Plugging Procedure Federal 23 #4 API – 30-041-10530 Sec. 23, T7S, R33E, UL-P 660' FSL 660' FEL

## Federal 23 4 30-041-10530 Ridgeway Arizona Oil Corp July 2, 2018 Conditions of Approval

## Permanent Abandonment of Production Zone Conditions of Approval

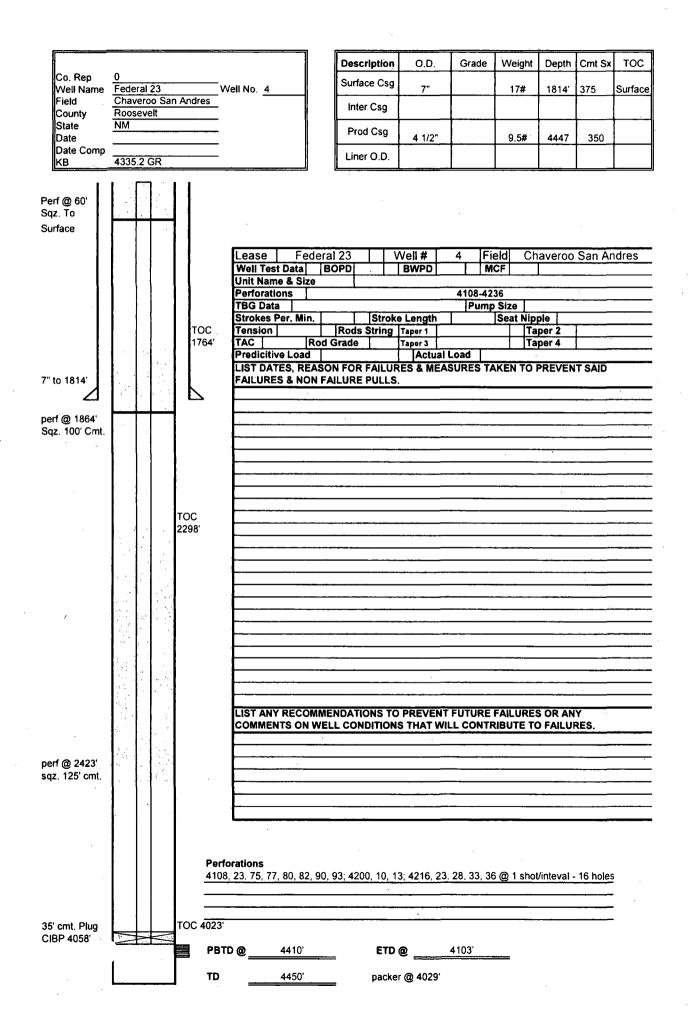
- 1. Operator shall place CIBP at 4,058' (50'-100' above top most perf) and place 35' of Class C cement on top as proposed. <u>WOC and TAG.</u>
- 2. Operator shall perf and squeeze as proposed at 2,423'. Operator shall place a balanced Class C cement plug from 2,423'-2,154" to seal the top of the Yates formation. <u>WOC and TAG.</u>
- 3. Operator shall perf and squeeze at 1,864'. Operator shall place a balanced Class C cement plug from 1,864'-1,764' to seal the Shoe and the top of the Salt. <u>WOC and TAG.</u>
- 4. Operator shall perf and squeeze at 60' bringing cement to surface.
- 5. See Attached for general plugging stipulations.
